PROPOSED R034 - TRUNK ROAD
MOUNTAIN RIDGE ROAD, NEW BEITH
FOR 'FRASERS PROPERTY AUSTRALIA'

REV	DATE	DESIGN	DRAWN	REVISION DETAILS		DRAWN	STATUS			SCALE 1:2000 20 0 20 40 60 80 100 A1 1:4000  A3	CLIENT FRASERS PROPERTY AUSTRALIA ASSOCIATED CONSULTANT RPS GROUP (07) 3539 9500	PROJECT NAME NEW BEITH - PRECINCT B MOUNTAIN RIDGE ROAD NEW BEITH	DRAWING TITLE		
A	02.05.25	BR	DH	ORIGINAL ISSUE	TG	NOT FOR CONSTRUCTION	DATE 21.08.25	COVER PLAN							
B	21.08.25	BR	TG	RFI RESPONSE				PROJECT No.					DRAWING No.	REVISION	
					DESIGN	APPROVED DANIEL COLLINS RPEQ 18631	DATE 21.08.25								
					BR	 FOR AND ON BEHALF OF COLLIER'S INTERNATIONAL ENGINEERING & DESIGN PTY LTD

REV	DATE	DESIGN	DRAWN	REVISION DETAILS			DRAWN	STATUS			SCALE	CLIENT	PROJECT NAME	DRAWING TITLE				
A	02.05.25	BR	DH	ORIGINAL ISSUE			TG	NOT FOR CONSTRUCTION						GENERAL NOTES				
B	21.08.25	BR	TG	RFI RESPONSE														
							BR	APPROVED					RPEQ 18631	DATE	21.08.25			
								DANIEL COLLINS										
			</

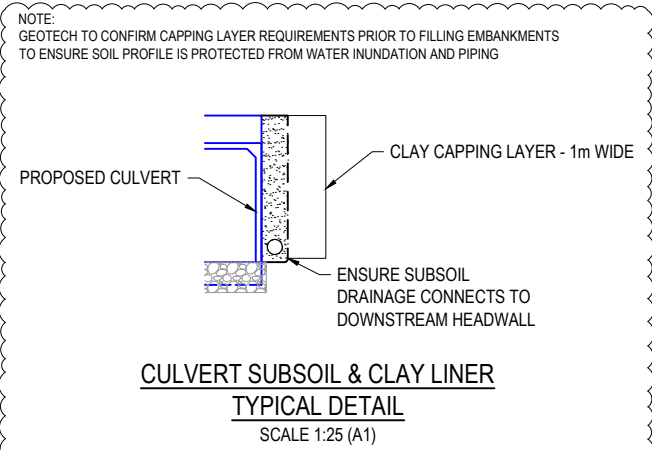
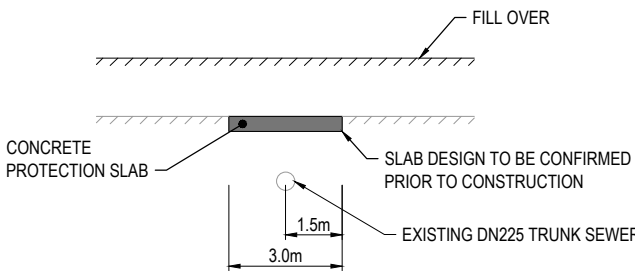
Basins and their associated works are not approved.

AMENDED IN RED

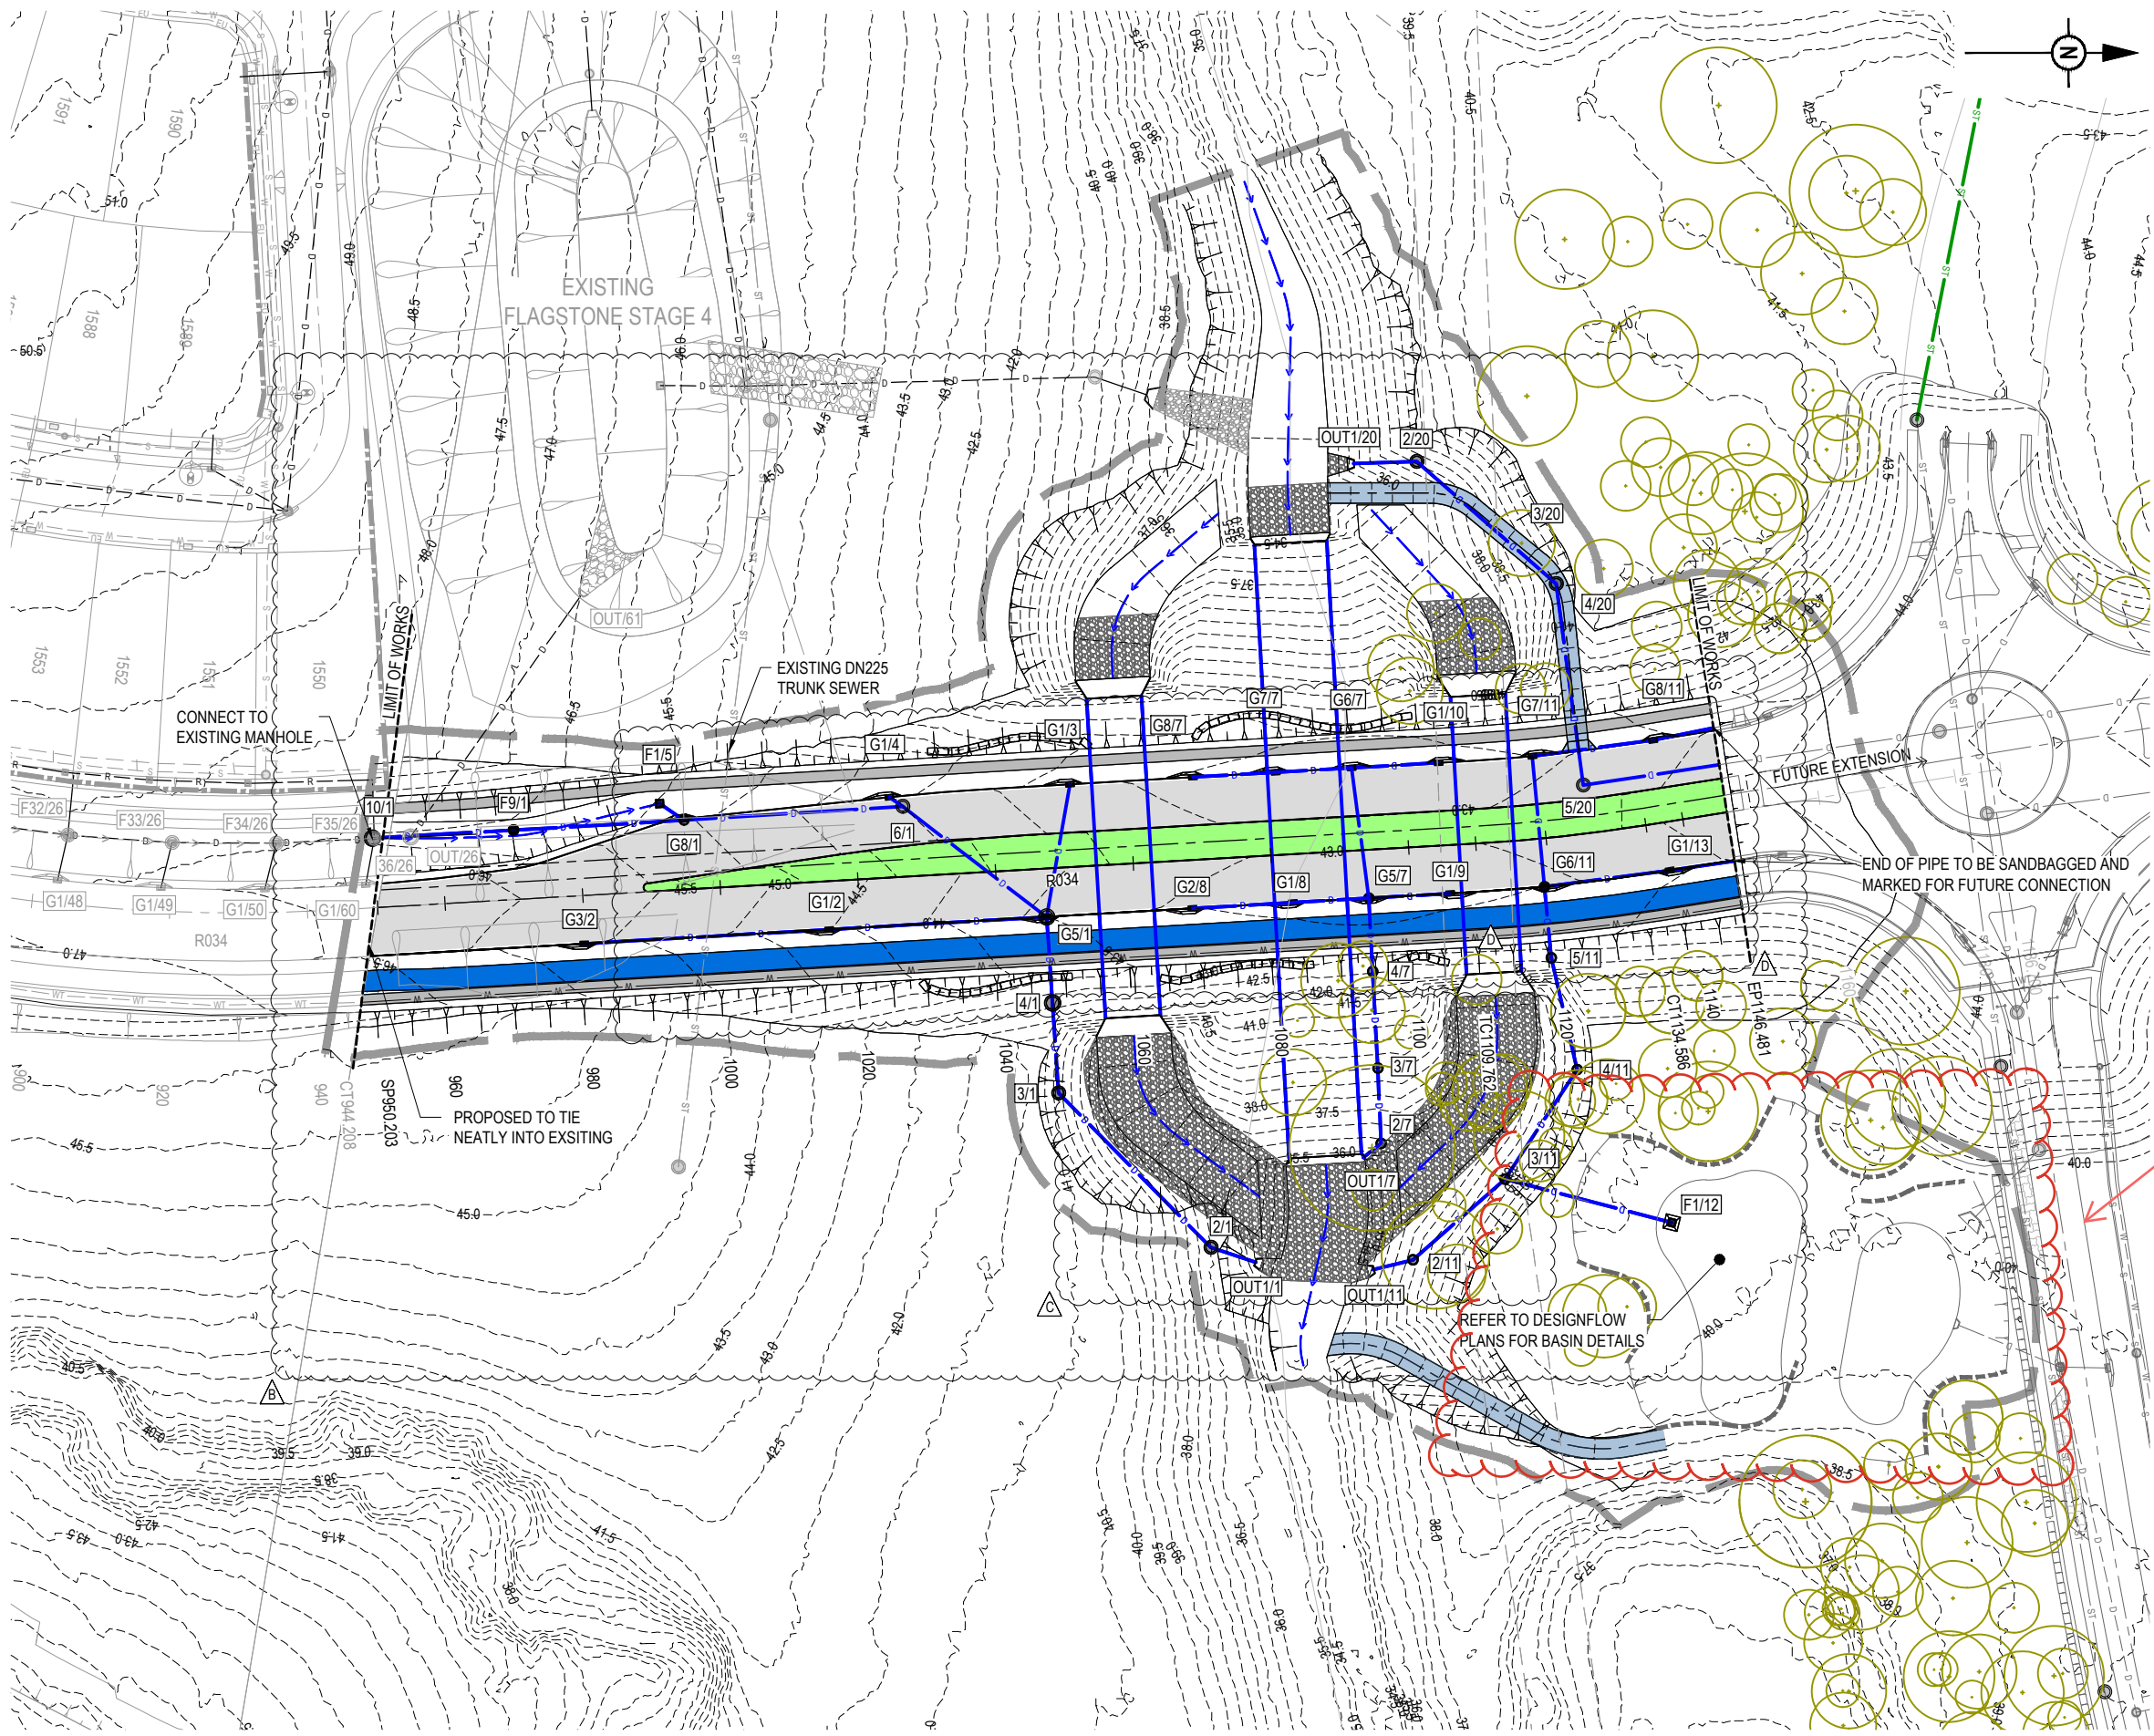
Basins and their associated works are not approved.

AMENDED IN RED
